INTERNATIONAL BOUNDARY AND WATER COMMISSION
UNITED STATES AND MEXICO

April 20, 2020

Subject: Hydraulic Analysis for the Constructed Bollard Wall in the Rio Grande Floodplain near Mission, Texas

Figure 1: Derived Manning's Roughness Values after Calibration

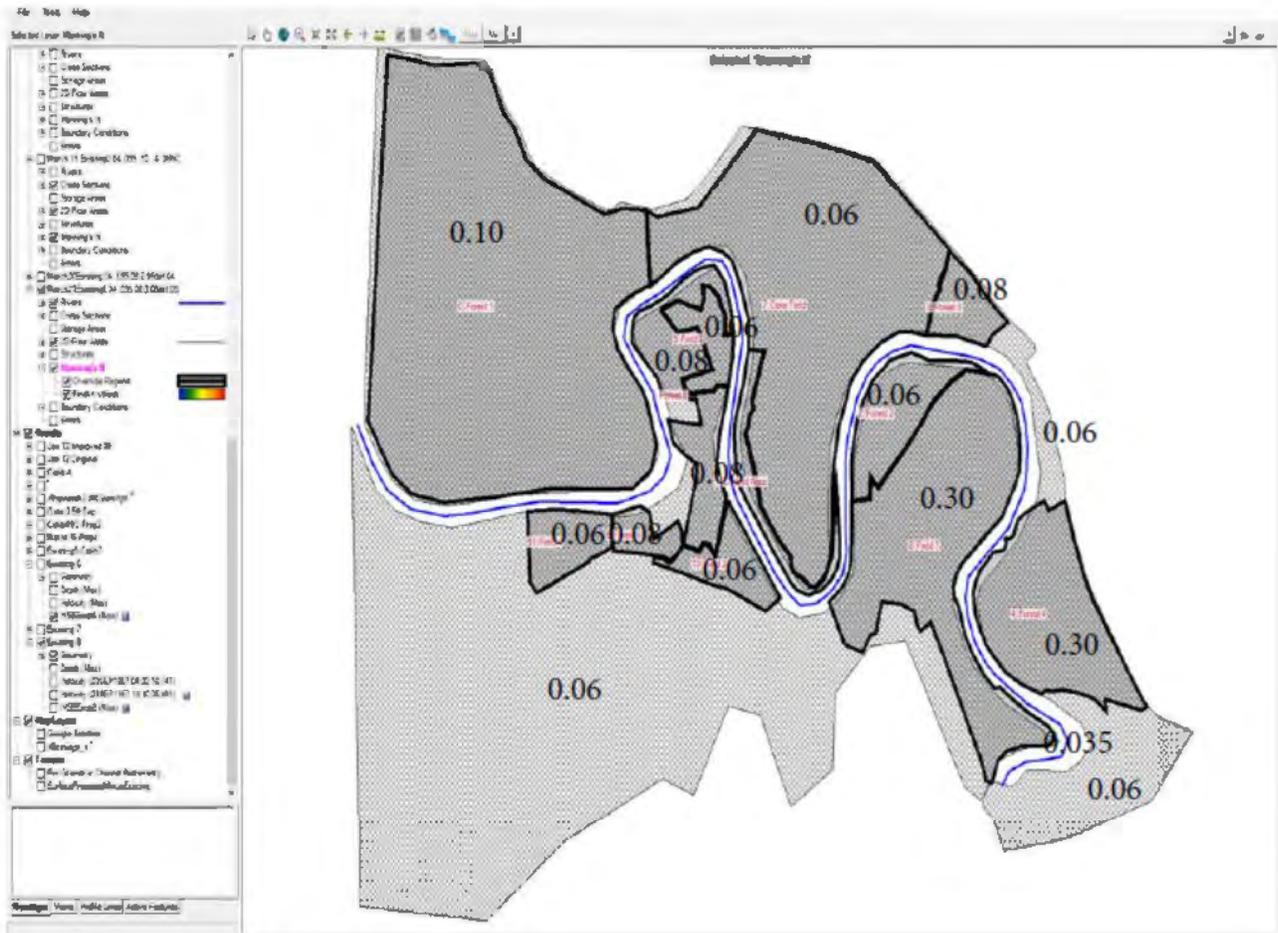
The Fisher Industries model divides the modeled area into various regions based on ground cover. We utilized the same regional grouping but adjusted the roughness values for the different regions to obtain a reasonable match of the modeled and observed WSE values for the calibration. The finalized roughness coefficient values based on the calibration model run are shown in **Figure 1**. Channel roughness value is 0.035 with 0.04 for both overbanks. Floodplain comprises row crop (corn), forest and cleared area. Roughness coefficient values for various forest areas vary from 0.08 to 0.3, including some areas with 0.10. Roughness values had to be increased to 0.3 at the downstream areas to match the observed WSE.
